**Re: McDonald's at San Mateo and Academy
Request for Permanent C.O. - Accepted
Engineer's Stamp Date 2-9-16 (E18D019C)
Certification date: 5-27-16**

FILENAME: C7.0 GRADING PLAN.dwg

C7.0

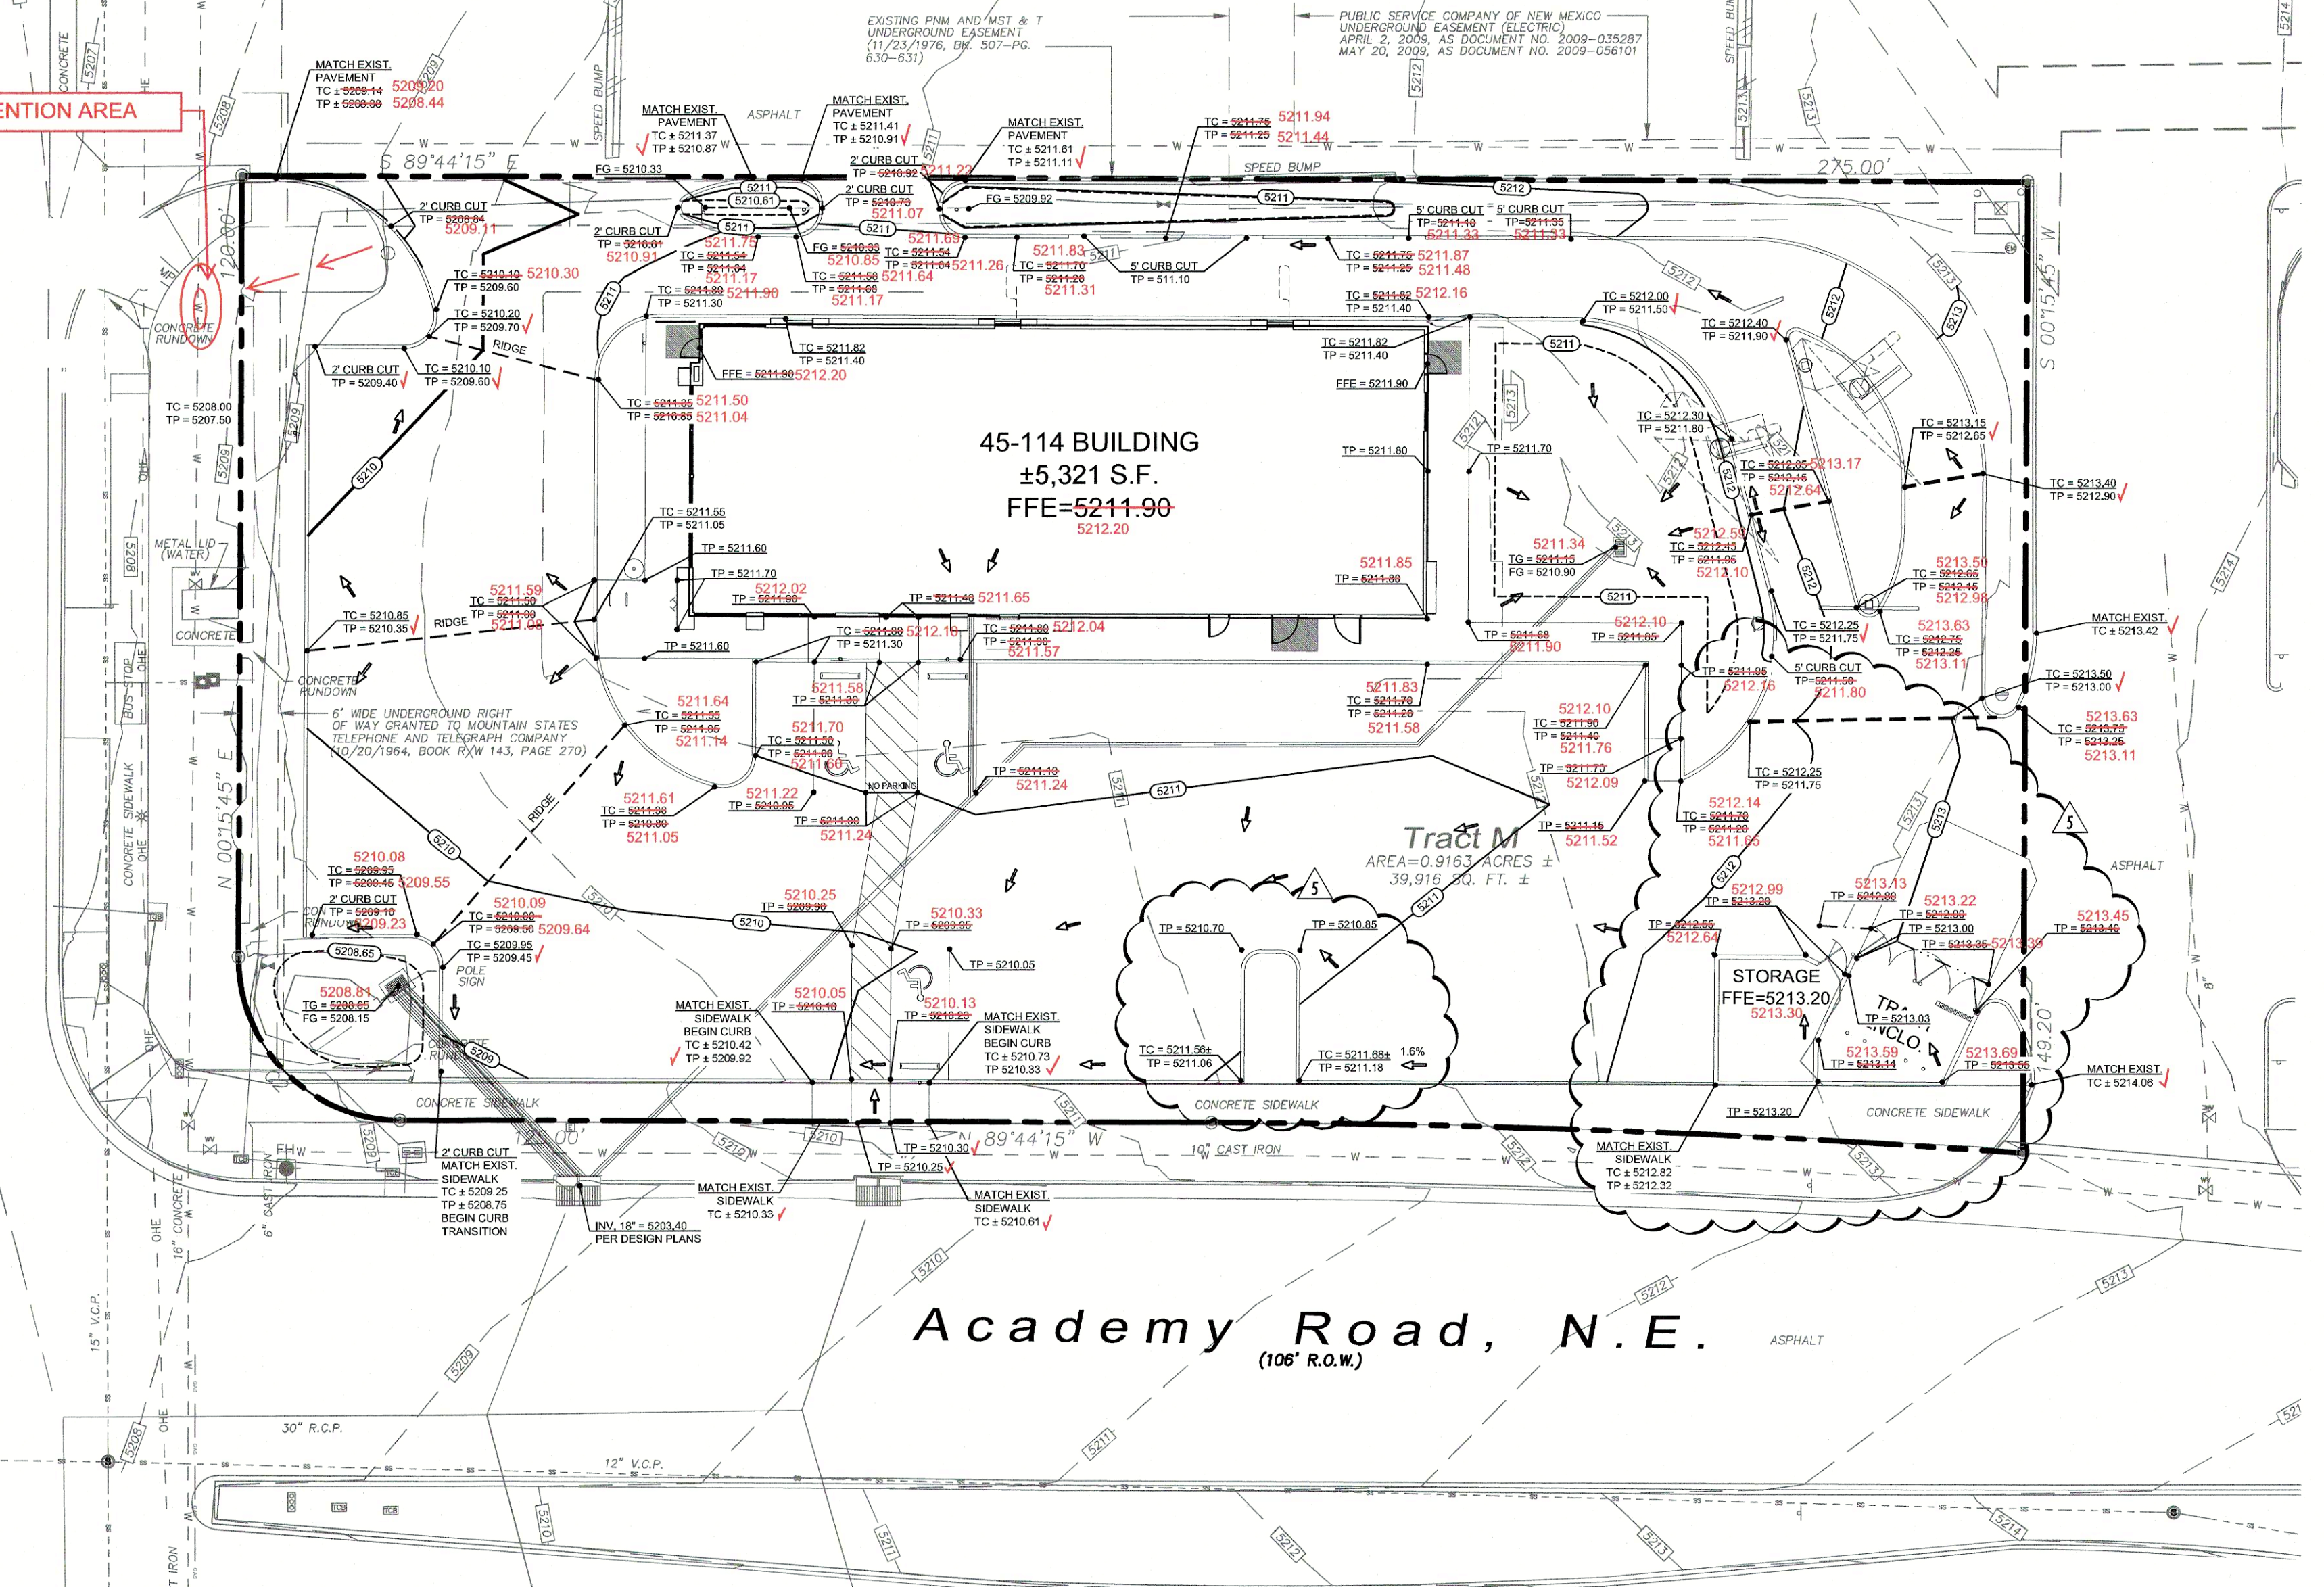
THE DESIGNED FLUME WAS NOT BUILT. SEE EDITED PORTION SHOWING RETENTION AREA THAT WAS BUILT INSTEAD.
